THE CADILLAC SERVICEMAN

PUBLISHED BY
CADILLAC MOTOR CAR DIVISION
DETROIT, MICHIGAN

NOVEMBER
1960

Fig. 1

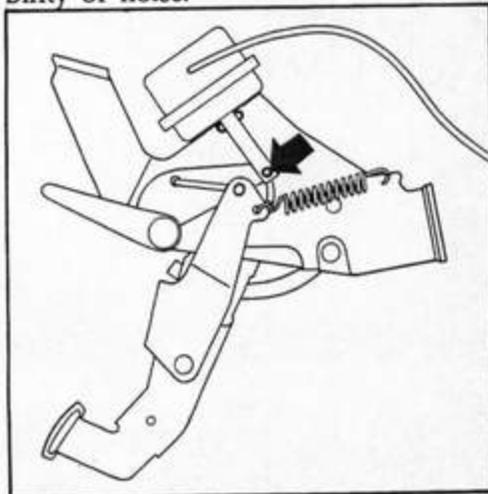
PIR A RATTLE condition may develop in the parking brake assembly, due to excessive play in the vacuum unit release linkage, on some 1961 cars before approximate Engine No. 019000.

This condition can be corrected by stretching a small "O" ring, Part No. 1453923, or similar ring over the rivet head, as indicated in Fig. 1.

Cars after the above Engine Number will have a spring wave washer added at this location to eliminate any possibility of noise.

Fig. 2

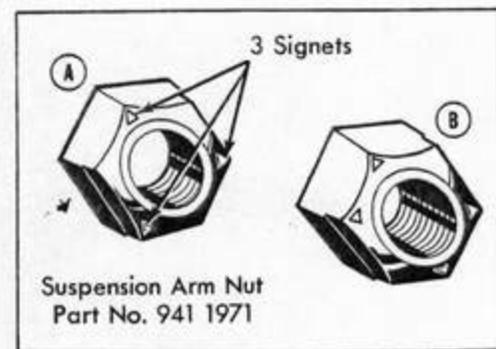
AT the very start of 1961 production, it was found more satisfactory to install the bolts that hold the upper front suspension arm shaft to the frame with the bolt heads down, rather than up, as originally planned. With this arrangement, the bolt heads contact the frame and the Stover type lock nut tightens against the harder material of the suspension arm shaft.

This production change makes it necessary to change the torque specification on Pages 4-26 and 4-39 of the 1961 Shop Manual from 110-120 foot-pounds to 55-70 foot-pounds, as the drive for tightening is now applied to the nuts rather than to the bolt heads.

When making this change in your Shop Manuals, be sure to cross out the word "bolts", as this new specification applies only when the wrench is used on the nuts. The suspension arm shaft-to-frame nuts should be torqued to 55-70 foot-pounds. This torque should be checked during Pre-Delivery Conditioning.

Servicemen should also check for the correct *type* Stover nuts at this location on cars before Engine No. 007000, by cleaning the top of the nut and counting the small embossed signets on the top edge of the nut. A correct upper suspension arm shaft nut, Part No. 9411971, will have three identifying signets, see "A" Fig. 2. A contrast to this would be the Stover nut "B" with 4 signets as shown in Fig. 2. If a car is encountered with nuts having 4 signets, remove them and install three-signet nuts, Part No. 9411971, tightening them to 55-70 foot-pounds.

Fig. 3

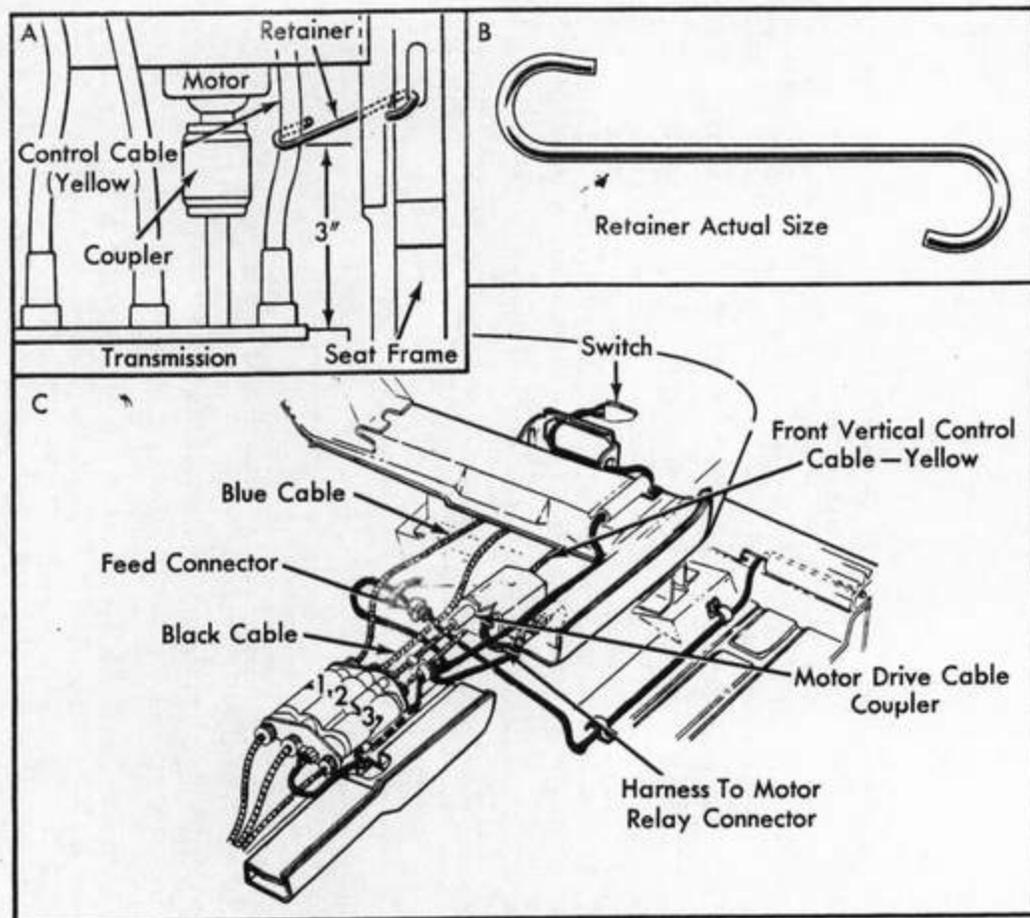
ON 1961 cars equipped with six-way seats a small "S" type wire retainer is positioned around the front yellow control cable 3 inches from the transmission, and hooked in the seat frame near the front edge of the motor, to route the control cable away from the rubber coupling on the motor drive cable, see "A"—Fig. 3.

When servicing 1961 cars equipped with six-way seats, be sure this clip is installed to avoid excessive whipping and chafing between the front yellow control cable and the motor drive cable rubber coupling.

An "S" type retainer can easily be fabricated as shown in "B"—Fig. 3 from a short piece of coat hanger or #10 wire, and effectively positioned around the cable and into the hole in the seat frame as shown in "A" Fig. 3.

Some last minute changes before the start of 1961 production were made in the routing of the six-way seat wire harness. Part "C" of Fig. 3 illustrates the latest harness routing, which has been in effect since the start of production. This routing will supersede the one illustrated on Page 15-48 in the 1961 Shop Manual. Please mark this Shop Manual illustration with a reference to "November 1960 Serviceman."

Fig. 5

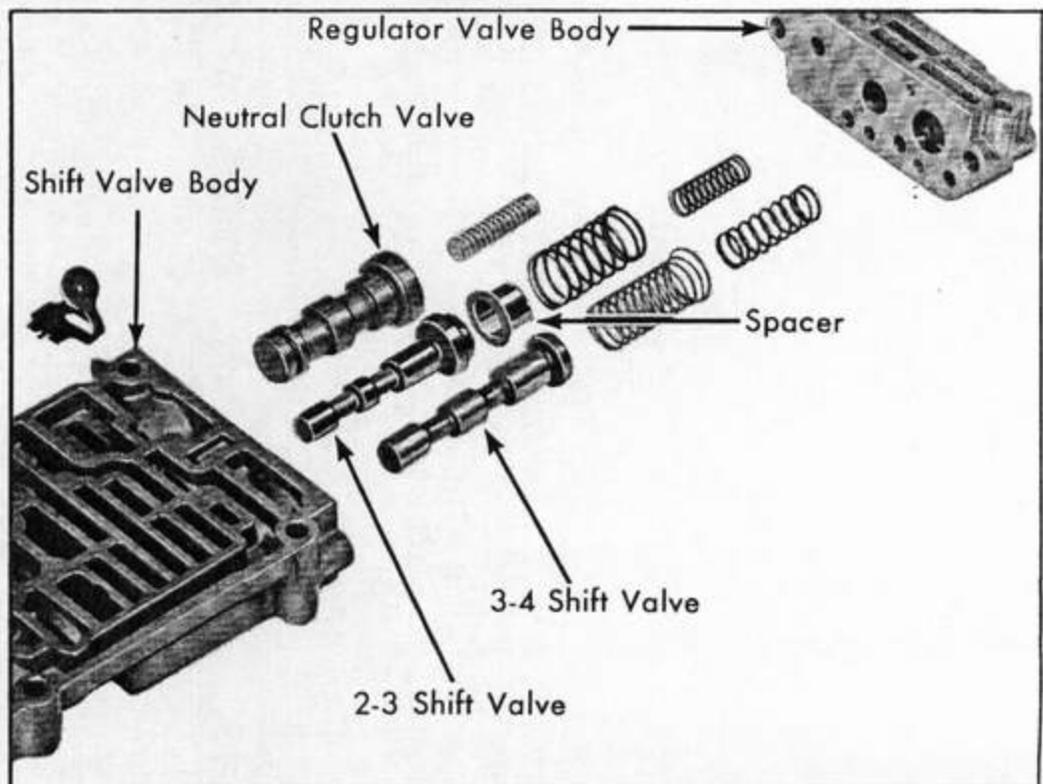
WHEN overhauling the shift valve body from a 1961 or late 1960 Hydra-Matic transmission, an additional spacer will be noted which is not pictured in the Shop Manual. This spacer fits on the end of the 2-3 shift valve with the rim of the spacer against the large land on the valve, as shown in Fig. 5.

A steel backing washer has also been added between the rear clutch hub and rear unit clutch cover to reduce galling of the bronze thrust washer and reduce wear on the clutch cover. The bronze

thrust washer is positioned next to the rear clutch hub and the steel backing washer is positioned between the bronze washer and the rear unit clutch cover with the flange on the backing washer toward the clutch cover.

Fig. 6

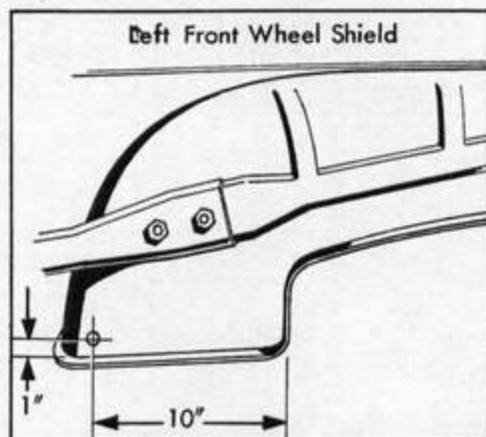
ON early 1961 cars equipped with Cruise Control, a metal strap was used to hold the two drive cables together to provide a uniform routing between the right fender dust shield and the engine.

However, it was found that some cables tend to reposition themselves, especially when strapped together, causing an interference and chafing action at the steering gear flexible coupling.

In order to eliminate any possibility of interference on 1961 cars equipped with Cruise Control, Servicemen should install a plastic type strap, Part No. 1476457, around the two cables and anchor the strap to the right dust shield, approximately 1" above the bottom flange of the shield, where it passes over the frame side bar directly across from the flexible coupling.

the ones used to route and position electrical cables, can be easily installed by drilling a 1/4" hole at the specified location, as shown from inside the front wheel shield in Fig. 6. Mark the location from the underhood side, and drill from the under fender side. Then press the strap anchor peg into the hole, route the cables carefully in this area, and lock them in position with the strap.

Fig. 7

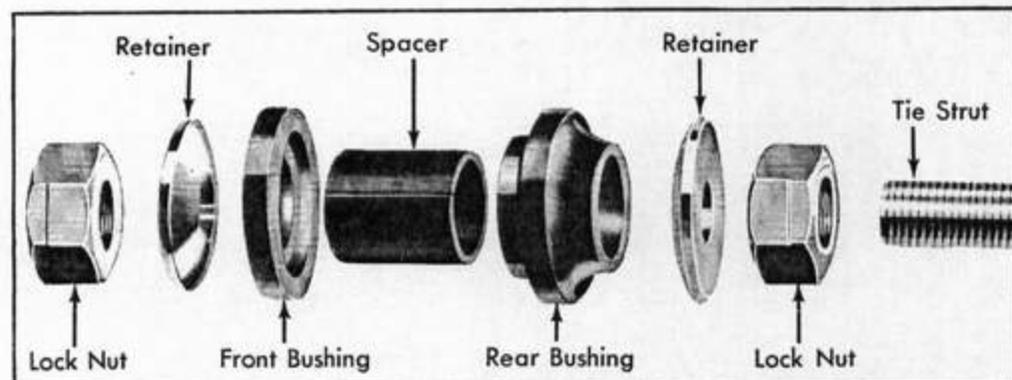
THERE have been some reports that the front tie strut spacers are cutting and collapsing into the inner diameter of the retaining washers on the tie-strut where it bolts to the frame front cross member.

This condition can generally be distinguished by a creaking noise in the front suspension, not attributable to ball joints or upper bushings, but caused by the contact between the spacers and the frame. In addition, wheel "thump" resulting from excessive fore-and-aft movement of the front wheel when stopping was also

When any of the above symptoms are noticed, the rubber bushings assemblies on the tie strut should be removed so that the spacers and retaining washers can be examined for damage and replaced if necessary.

New stover nuts should always be installed whenever the tie-strut is disassembled at this point. If the new stover nut is thread onto the tie-strut and loses its self-locking qualities on rough threads, it should be replaced with another nut. Threading the first new nut on the tie-strut should clean the threads sufficiently so the end nut can be properly set and torqued.

In addition, torque the 3/4 - 16 stover nuts that preload the tie-strut rubber bushing retaining washer to 30-40 foot-pounds instead of the 55-70 foot-pounds previously recommended. This torque change, in addition to a closer inspection of the tie-strut threads, was instituted in production at Engine Number 010483.

Please change your Shop Manual accordingly.

Fig. 8

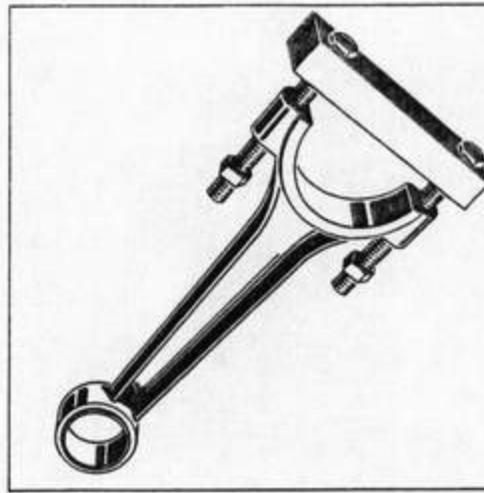
A "BUZZING" noise during heavy acceleration, may be experienced by Servicemen on a few 1961 cars. The noise, which seems to originate in the parking brake assembly, is caused by the exhaust pipe being raised at high engine torque, and grounding lightly against the parking brake bell crank.

There are several possible causes of this condition—the engine may be slightly mispositioned, with the high point at the left engine mount, the exhaust pipe may have a slight deviation in contour causing it to hang slightly high at the bell crank area, or the parking brake pedal to bell crank cable may be too long.

Approximately $\frac{1}{2}$ " to $\frac{3}{4}$ " of clearance is needed between the bottom edge of the bell crank and the top of the exhaust pipe. When interference occurs, only an additional $\frac{1}{8}$ " to $\frac{1}{4}$ " more than the existing clearance is usually necessary.

When this grounding condition is encountered, sufficient clearance can usually be obtained by flattening the exhaust pipe directly below the bell crank. This can be done quickly and neatly by fabricating a simple tool from a discarded engine connecting rod, two $\frac{3}{8}$ " x 4" bolts and nuts, and a $\frac{3}{4}$ " or 1" square piece of bar stock, as shown in Fig. 8. The tool can then be clamped around the pipe, positioning the flat bar directly below the bell crank, and tightening the nuts. The pipe should not be flattened more than $\frac{1}{4}$ ".

Fig. 9

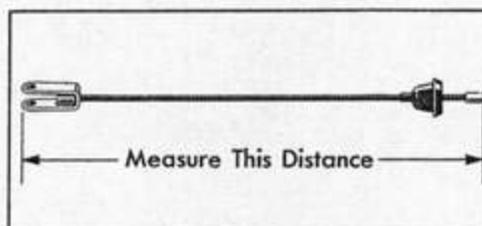
(front) cable assembly and measure the distance shown in Fig. 9. This cable, Part No. 1475685, should not measure over $14\frac{1}{8}$ " long. If the cable assembly is over this length, replace the cable.

When the interference remains on series 75 or Commercial cars after performing the above operations, remove and measure the bell crank to parking brake (front) cable assembly as above. If the cable is $15\frac{3}{4}$ " long, it is an early production unit, Part No. 1472147, and it can be replaced with a $\frac{3}{8}$ " shorter cable, which is presently used in production on this style car, Part No. 1477399. The longer cable, Part No. 1472147, is still applicable for 1959 and 1960 cars.

Fig. 10

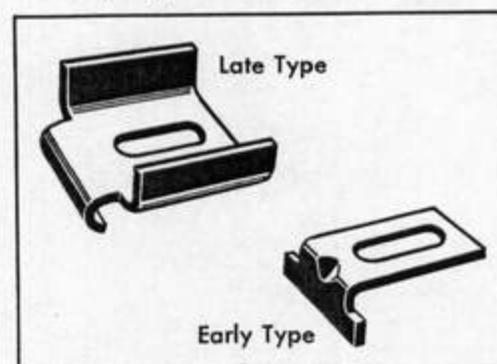
IF an owner of an early 1961 Cadillac, prior to Engine Number 004463, complains of the glove box door falling open, an effort should be made to correct this condition by adjustment of the striker.

In cases where adjustment fails to correct this condition, a more durable striker, Part Number 1477268, and attaching screw, Part Number 9417414, should be installed.

To eliminate the possibility of glove box doors falling open on future cars, this change was incorporated in production beginning with Engine Number 004463. The two strikers, late type and early type, are shown in Fig. 10.
